Planning Application Number: 24/00828/REM

Application Address: Land South Of 295 Main Street Stanton Under Bardon Leicestershire

Application Type: Reserved Matters

### **Substantive Response provided in accordance with article 22(5) of The Town and Country Planning (Development Management Procedure) (England) Order 2015:**

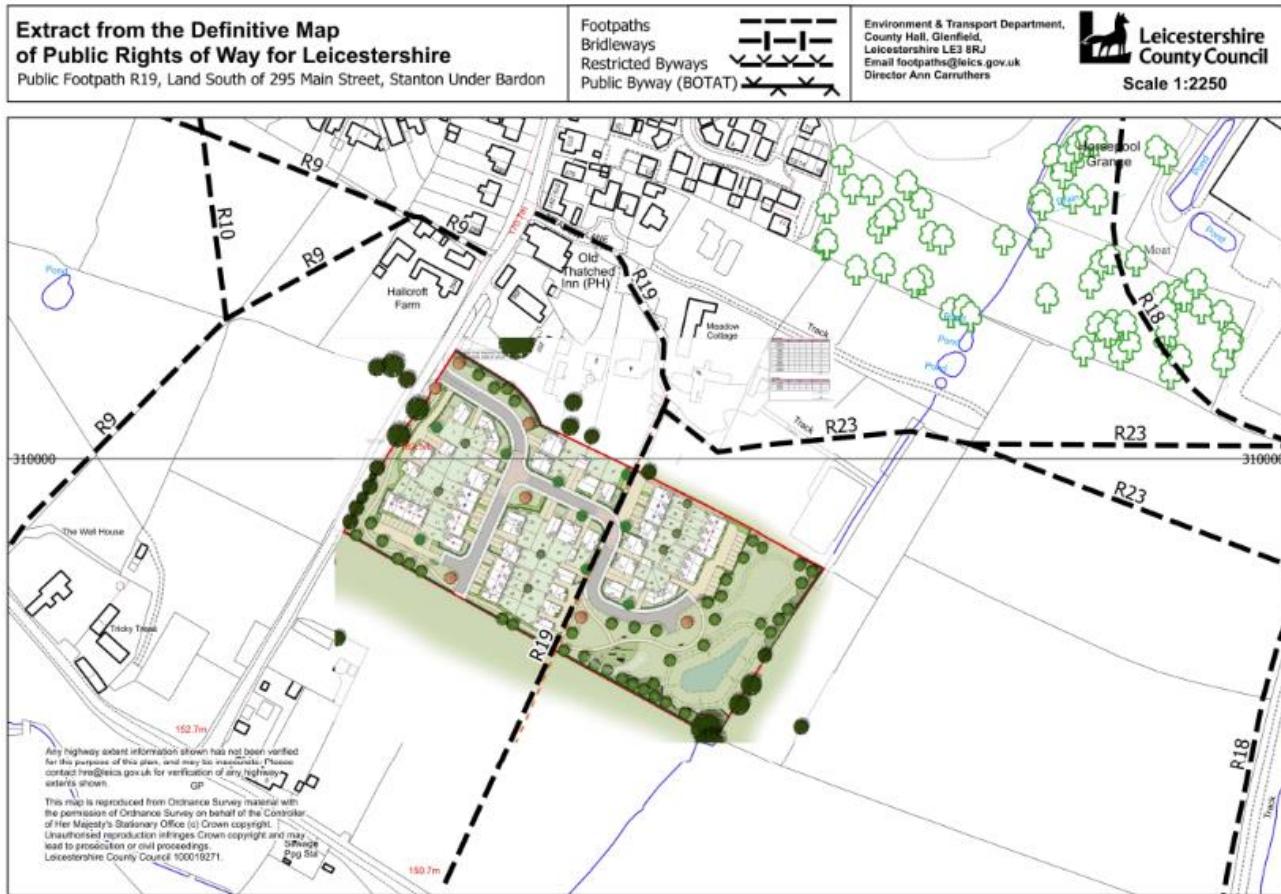
The LHA note that some of the driveways indicated on the submitted drawing titled 'Planning Layout' drawing no. SUB/PL/001 Revision A are bound on either one side or both sides. Therefore, in order to accord with the guidance set out in the LHDG, the access should include an additional 0.5m if bounded by a wall, fence, hedge, line of trees or other similar obstruction on one side, or 1m if bounded on both sides.

In terms of the dimensions of the parking spaces, several plots have dimensions below the widths required within Part 3, Paragraph 3.165 as they require additional widening to account for walls/ fences etc bounding one or both sides of the parking space. The LHA would ask the Applicant to ensure that parking space dimensions are in accordance with Para. 3.165 of the LHDG.
